CITY OF ALBUQUERQUE

**Re: Mesa Del Sol Montage Unit 2, Portrait Park Swimming Pool
Grading and Drainage Plan
Engineer's Stamp date 03-20-2013 (R16/D003B)**

GRADING AND
DRAINAGE PLAN

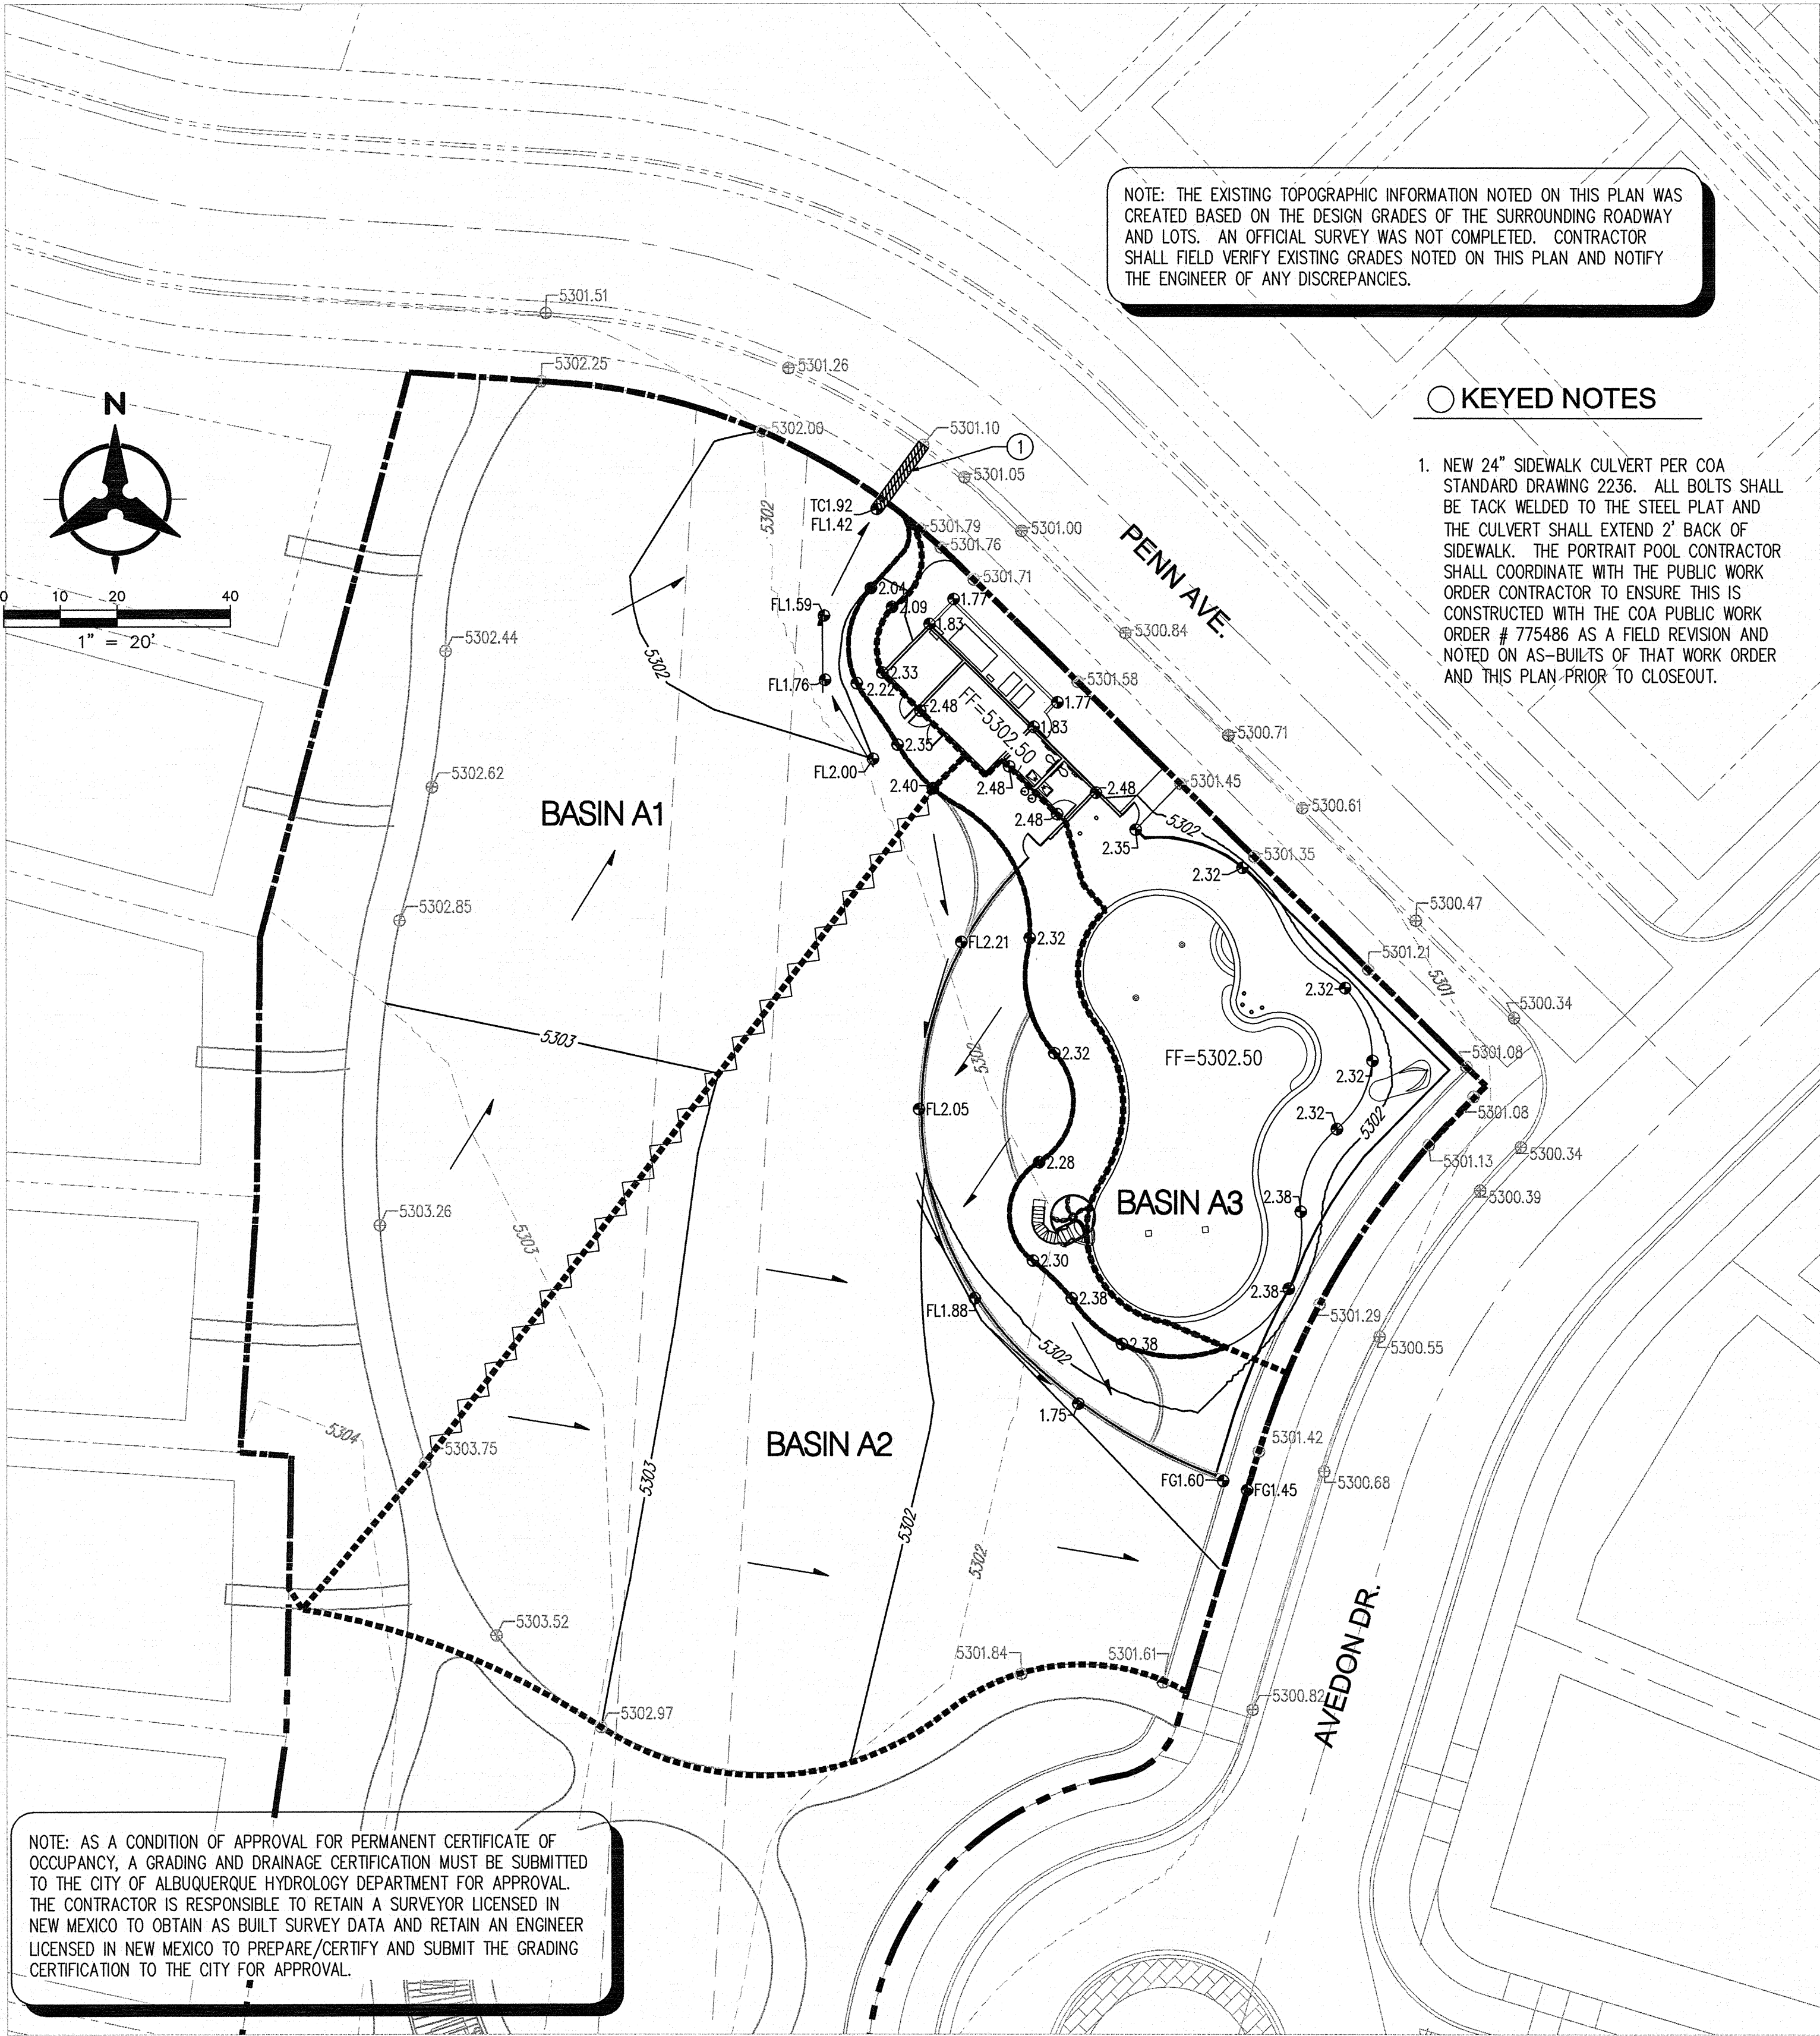
Based upon the information provided in your submittal received 03-20-13, the above referenced plan is approved for Building Permit. If $\frac{3}{4}$ an acre or more is being disturbed a Topsoil Disturbance Permit will be required.

Please attach a copy of this approved plan to the construction sets when submitting for a building permit. If the approved plan is not attached to the construction set, Hydrology will reject the construction set for Building Permit.

Prior to Certificate of Occupancy release, Engineer Certification per the DPM checklist will be required. If you have any questions, you can contact me at 924-3695.
